Recall Bulletin

SUBJECT: Rear Axle Cross Pin Fracture

MODELS: 2011 Cadillac Escalade, Escalade ESV, Escalade EXT 2011 Chevrolet Avalanche, Colorado, Express, Silverado, Suburban, Tahoe 2011 GMC Canyon, Savana, Sierra, Yukon, Yukon XL

This bulletin is being revised to expand the population involved, including the Chevrolet Express and GMC Savana. Please discard all copies of bulletin 10426E, issued January 2011.

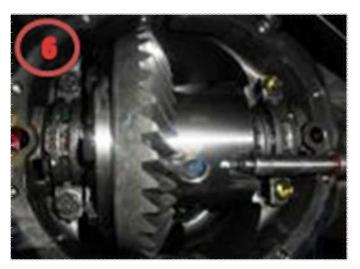
- 8. While holding one wheel, turn the other wheel until the lock screw is visible.
- 9. Determine if the rear axle cross pin must be replaced.

Note: If **BOTH** lines are not clearly visible on the cross pin, the cross pin MUST be replaced.

- If the head of the rear axle cross pin has orange and black paint marks or blue and black paint marks, do NOT replace the cross pin. Refer to illustration. Proceed to Step 14.
- If the head of the rear axle cross pin does NOT have a clearly visible orange and black paint mark, or a blue and black paint mark, (BOTH lines MUST be clearly visible), REPLACE the rear axle cross pin. Refer to illustration. Proceed to Step 10.

10. Remove the lock screw with a ratchet with a 5/16" hexagonal socket while holding the cross pin with a magnet. Dispose of the lock screw.

11. Remove the cross pin by pulling it with the magnet. Discard the cross pin.

12. Using a magnet, insert a new certified cross pin without moving the case position, aligning the cross pin hole with the lock screw hole.

- 13. Replace the lock screw with a new one and tighten by hand until it stops. Apply a static torque of 35 Nm (26 lb-ft) with a pre-set clicker wrench. Certify the torque applying a slash through the lock screw head and the differential case.
- 14. Visually inspect the gasket for damage and replace if necessary.
- 15. Position gasket and cover pan ensuring proper alignment making sure not to damage the gasket.
